Access Compliance Report

Public Rights-of-Way

(Curb Ramps)

Intersection ID: 14726	Main Street: REMOUNT_RD	Cross Street: S_TRYON_ST	Location:	E
ADA ID: 4982C3086B34	Ramp Type: Perp	Initial Pass/Fail: Fail	Overall Compliance: No	Severity Score: 12.5

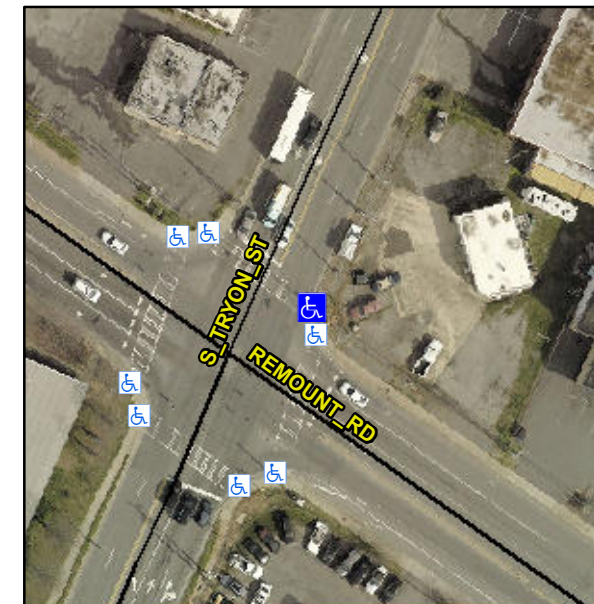
Not Found, R304.2.2

Compliance	Description	Data	Compliance	Description	Data
N/A	Ramp Length (in)	55.0	No	Ramp Slope (%)	10.9
Yes	Ramp Width (in)	48.0	Yes	Ramp XSlope (%)	1.2
N/A	Flare Type LT	N/A	N/A	Flare Type RT	N/A
N/A	Flare Slope LT (%)	N/A	N/A	Flare Slope RT (%)	N/A
N/A	Flare Traversable LT?	N/A	N/A	Flare Traversable RT?	N/A
N/A	Landing Length (in)	N/A	N/A	DWS Provided?	N/A
N/A	Landing Width (in)	N/A	N/A	DWS Contrast?	N/A
N/A	Landing Slope (%)	N/A	N/A	DWS Length (in)	N/A
N/A	Landing X Slope (%)	N/A	N/A	DWS Full Width?	N/A
N/A	Landing Curb? (Y/N)	N/A	N/A	DWS Offset (in)	N/A
N/A	Shared Landing?	N/A			
N/A	Gutter Ponding?	N/A	N/A	Gutter Slope (%)	N/A
N/A	Gutter Lip Ht (in)	N/A	N/A	Gutter X Slope (%)	N/A
N/A	Painted X Walk1?	Yes	N/A	Painted X Walk2?	N/A
	X Walk 1 Direction	To NW		X Walk 2 Direction	N/A
N/A	X Walk 1 Width (in)	101.0	N/A	X Walk 2 Width (in)	N/A
	X Walk 1 Slope (%)	1.1		X Walk 2 Slope (%)	N/A
	X Walk 1 X Slope (%)	1.2		X Walk 2 X Slope (%)	N/A

Possible Solutions:

Remove & Replace Entire Ramp.
